Rezoning Transportation Analysis

Petition Number: Insert Zoning Petition #2021-277

Revision Log:	Date	Description
	05-18-2022	First Review (WB)

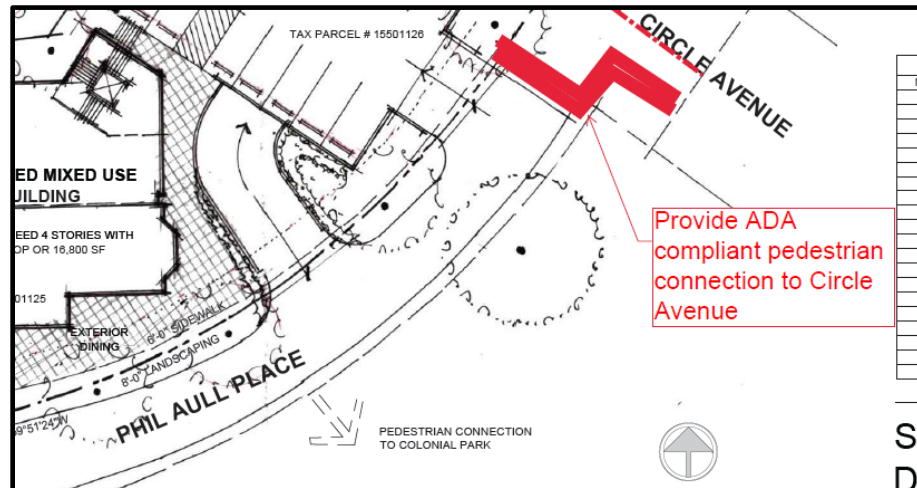
- Site plan and conditional notes revisions are needed to provide an ADA compliant pedestrian connection from Phill Aull Place to Circle Avenue.

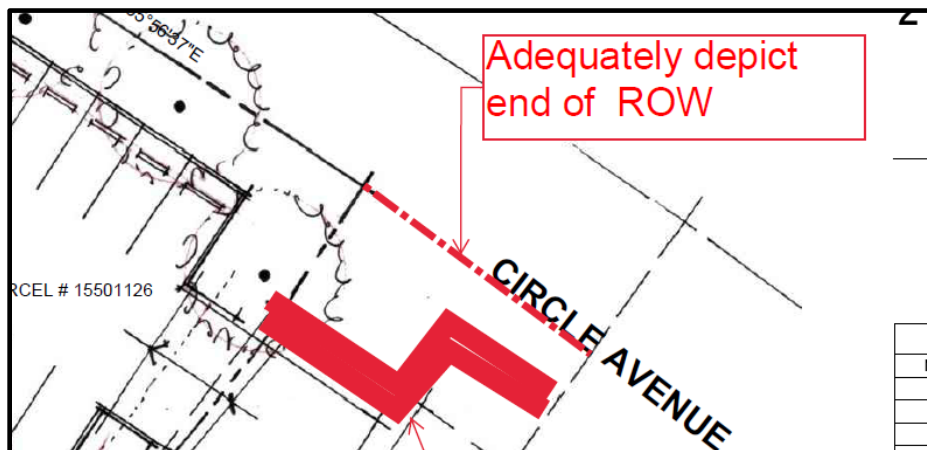
- Adequately depict the existing Circle Avenue right-of-way at Phill Aull Place.
